Re: Work Plan Addendum for Additional Assessment
Former Chevron Service Station 90121
3026 Lakeshore Avenue
Oakland, California
Fuel Leak Case No. RO0000284

AGENCY LETTER

Subject: Request for Work Plan Addendum; Fuel Leak Case No. RO0000284 and Geotracker Global ID T0600100328, Chevron #9-0121; 3026 Lakeshore Avenue, Oakland, CA 94610

Figure 2
 SITE PLAN WITH PROPOSED SOIL VAPOR INVESTIGATION LOCATIONS
 FORMER CHEVRON SERVICE STATION 90121
 3026 LAKESHORE AVENUE
 Oakland, California

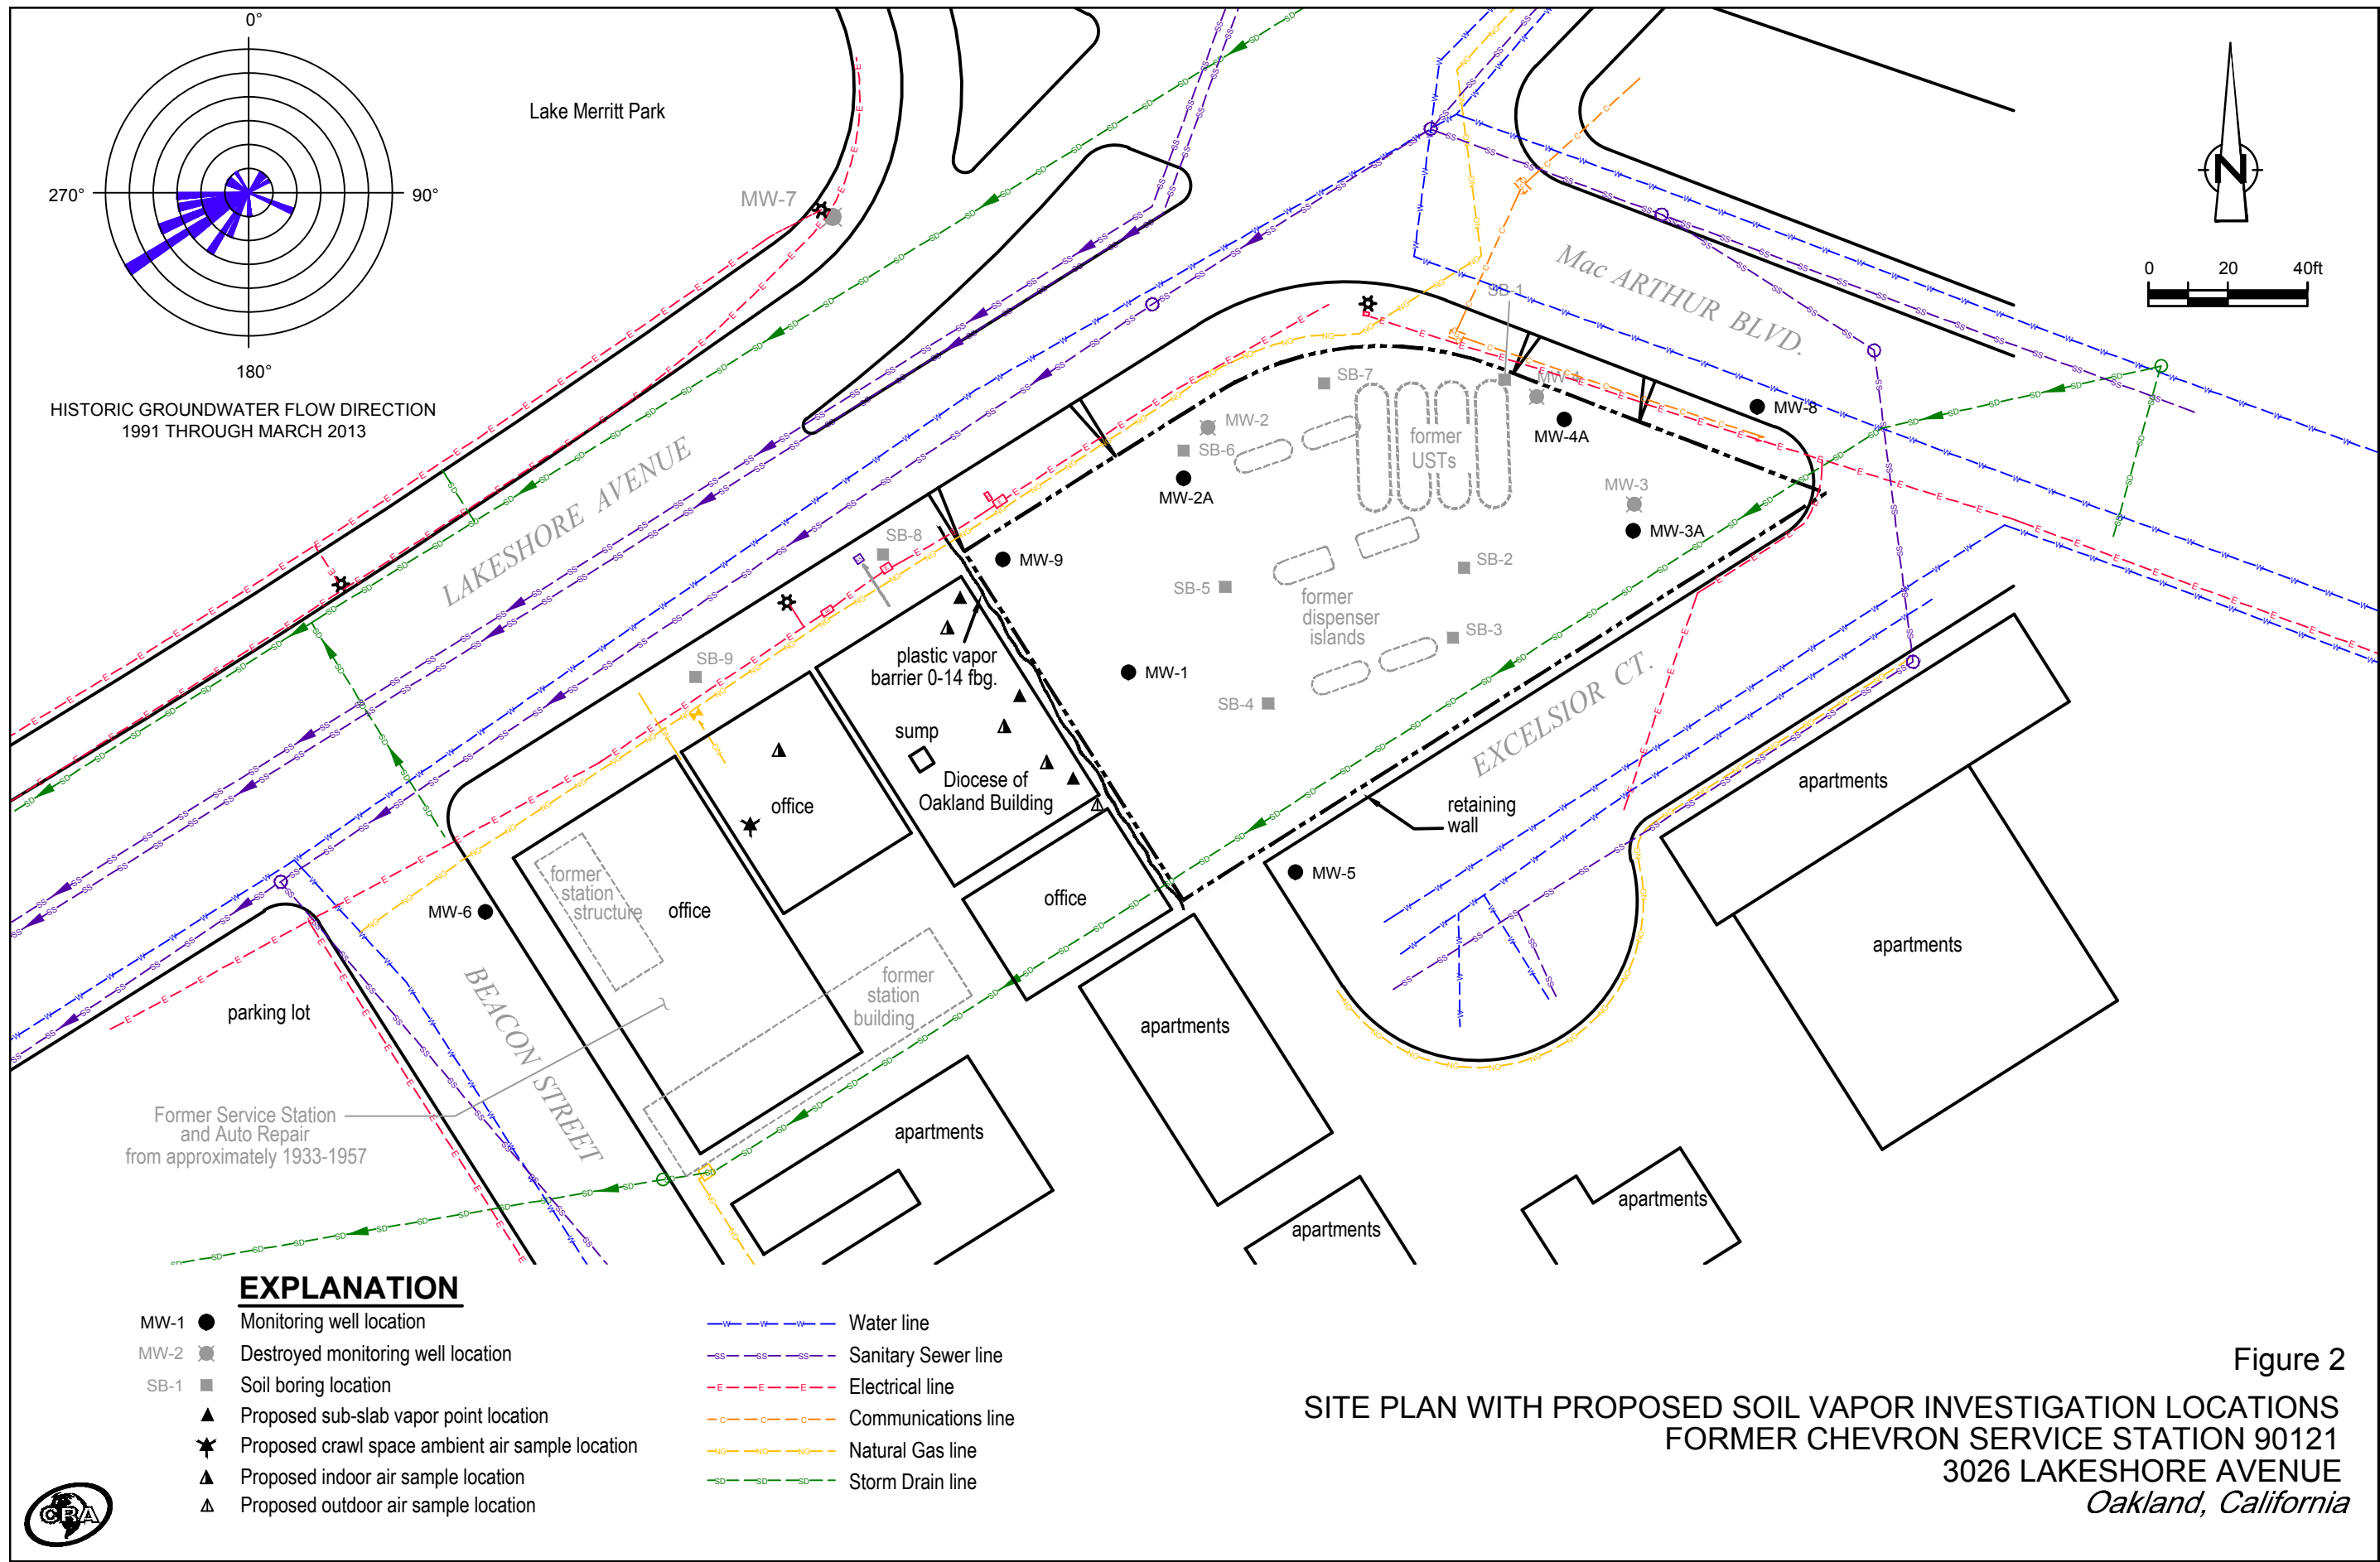
- d. **Vapor Intrusion Work Plan Addendum** – If changes other than those noted above are proposed, please incorporate them into a work plan addendum; otherwise a minimum submittal of a site vicinity plan with sub-slab probe locations and locations of sub-slab utilities is appropriate.

CRA proposes collecting sub-slab vapor, and indoor and outdoor air samples at 3014 Lakeshore Avenue (Figure 2). CRA will also collect air samples from the crawl space and indoor air at the property located at 3008 Lakeshore Avenue (Figure 2). To date, Chevron nor CRA has received any response from the property owner(s) at 3000 Lakeshore Avenue regarding the access agreement requests to conduct site investigation at their property. As discussed during the November 1, 2012 meeting, CRA will proceed without access to the property located at

Three sub-slab probes will be installed at 3014 Lakeshore Avenue based on the Department of Toxic Substances Control (DTSC) California Environmental Protection Agency October, 2011 *Guidance for the Evaluation and Mitigation of Subsurface Vapor Intrusion to Indoor Air (Vapor Intrusion Guidance)*. A rotary hammer drill will be used to create a 2-inch diameter and 1-inch deep "outer" hole that partially penetrates the concrete slab. A small portable vacuum cleaner will be used to remove cuttings from the hole. Removal of cuttings in this manner from the non-penetrated slab does not compromise soil vapor samples because there is a lack of pneumatic communication between sub-slab material and the vacuum cleaner.

CRA will collect three indoor air samples, one adjacent to each sub-slab probe location, and one outdoor ambient air sample at 3014 Lakeshore Avenue. In addition, one air sample from within the crawlspace beneath the building and one indoor air sample will be collected at 3008 Lakeshore Avenue. Approximately 48 hours prior to air sampling, a Building Survey and Building Chemical Screening form will be completed for each property as outlined in the DTSC guidance (2011). All samples will be collected from the breathing zone for approximately
